License # 45-09207-01
Docket # 03003333
Control No. 137935

Re: Request for Additional Information for License Renewal

Lewis-Gale Medical Center Request for Additional Information
14 Mach 2006 USNRC License #45-09207-01 Control #137935 Docket 03003333
Ver 1.1

6th Floor Layout:
Layout of patient holding area where patients who cannot be released under 35.75 will be sequestered

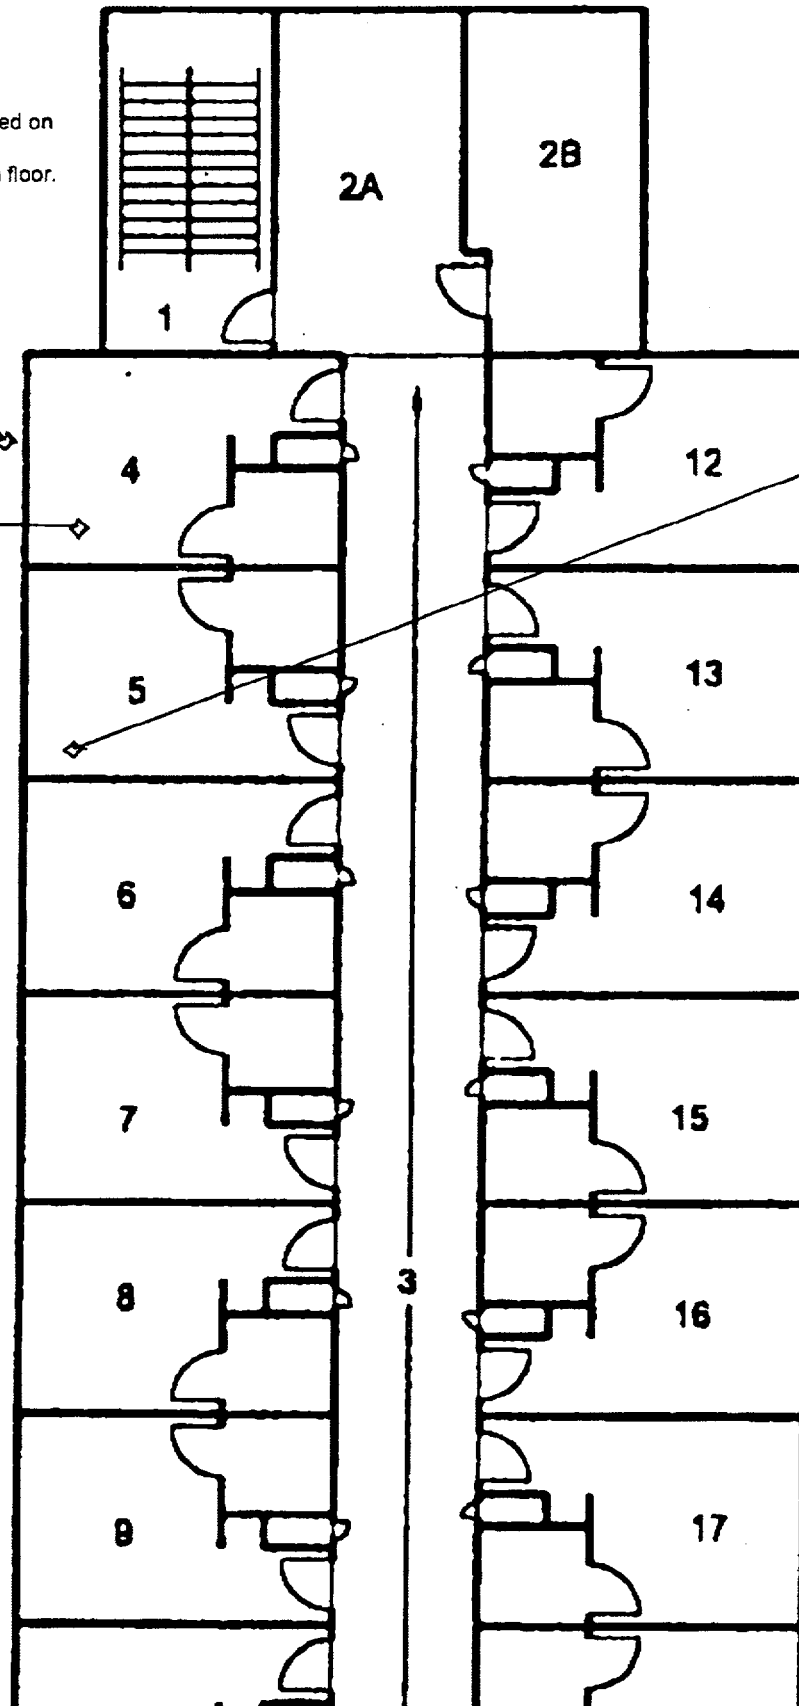
1. I have attached a new floor layout for the 6th floor where the patients undergoing Cs-137 low dose Brachytherapy are sequestered. Both of the test boxes were intended to point to room 664. I have moved the text box on the floor plan to indicate this.
2. Please find attached USNRC form 313A for Mr. James P. Nunn, MS to be added to our license application.

Room 664 is located on the exterior of the hospital on the 6th floor.

Room 664 is reserved for patients undergoing Low Dose Rate Brachytherapy.

Any Patients in Room 665 have their head positioned adjacent to room 666 to minimize unnecessary exposure.
